Subject ➤ Addition of Line filter

For Models ➤ BVC340, BVC350

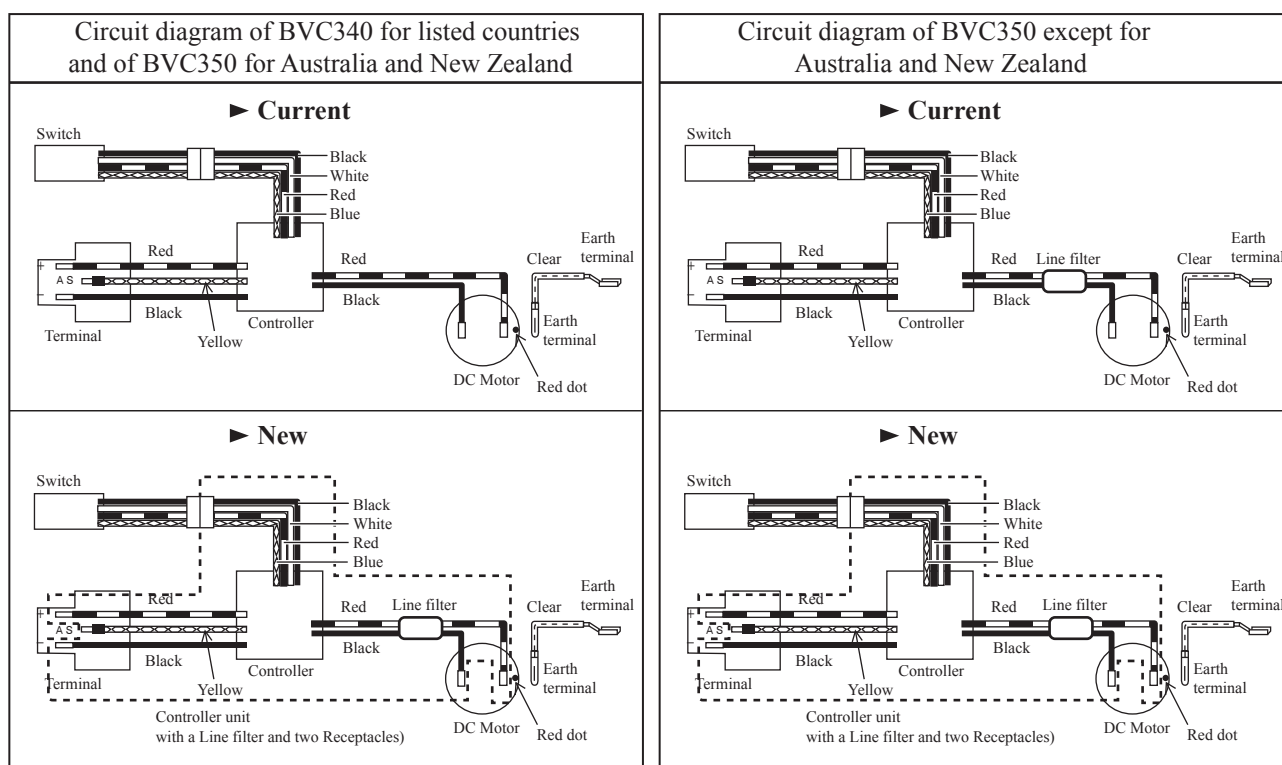
Description ➤ Line filter has been added to Controller and supplied as Controller unit for repairing to comply with EMC for DC tools.

Item No.	Current part	Q'ty	I/C	New part	Q'ty	Note
022	Controller 631974-0	1	←	Controller unit 638850-9	1	BVC340 for listed countries
022	Controller 620036-9	1	←	Controller unit 638851-7	1	BVC350 for Australia, New Zealand
022	Controller assembly 539197-3	1	Yes	Controller unit 638851-7	1	BVC350 for listed countries except Australia, New Zealand
---	Line filter 688161-2	1				The components of Controller assembly
---	Receptacle 654069-2	2
